XtremeAir GmbH, Harzstr.2, D-39444 Hecklingen Tel: +49 39267 60999 0, Fax: +49 39267 60999 20 www.xtremeair.de info@xtremeair.de	Document No. SB-XA42-2018-016
		Issue: A.00
DOA-Nr.: EASA.21J.360	Service Bulletin	Date: 20.06.2018

Subject:	Pilot's seat replacement
Aircraft type affected:	XA42
Serial numbers affected:	MSN 101 – 151
Compliance:	As user discretion
Time of Compliance:	During the next scheduled maintenance
Purpose:	To notify the owner of the subject aircraft of an optional replacement of the rear seat.
Background:	Contact between the shoulder harness and the rear seat can lead to cracks around the shoulder harness openings on the rear seat.
Manpower:	It is estimated that one (1) man-hours is necessary to apply this service bulletin.
Materials:	<p>The following materials are necessary and can be ordered through spares@xtremeair.de</p> <p>(1) ea. XA42-2510-205 Rear seat or: (1) ea. XA42-2510-206 Rear seat sight carbon and: (1) ea. XA42-5370-238 Headset plug socket cover (2) ea. AN4-11A Hexagon head bolt (2) ea. MS21083-N4 Self-locking nut (6) ea. AN960-416L Flat washer</p> <p>Consumables:</p> <ul style="list-style-type: none"> - Alcohol – or equivalent solvent cleaner - Ad

Figure 1: Position of the headset plug socket cover

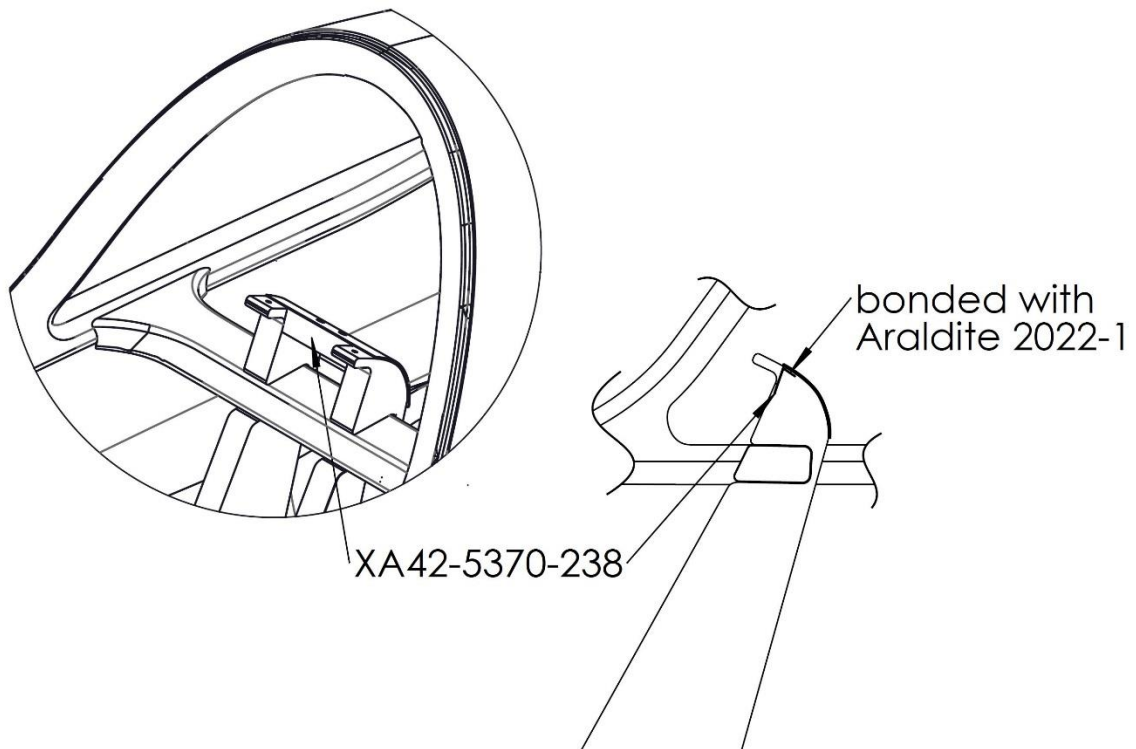
2. Exchange the fasteners of the pilot's shoulder harness with the delivered ones. Refer to chapter 25-10-02 of the AMM.
3. Identify the area to be prepared for the bonding of the headset plug socket cover to the headset plug support. Refer to Figure 1.
4. Prepare the headset plug socket support for bonding from the inside using P120 grit sandpaper.
5. Clean the surface to be bonded (dust and grease free).
6. Bond the headset plug socket cover XA42-5370-238 in accordance with Figure 1. Refer to the manufacturer's instruction for further handling advices.
7. Leave cure for at least 1 hour at room temperature.
8. Install the delivered rear seat XA42-2510-205 in accordance with chapter 25-10-01 of the AMM.
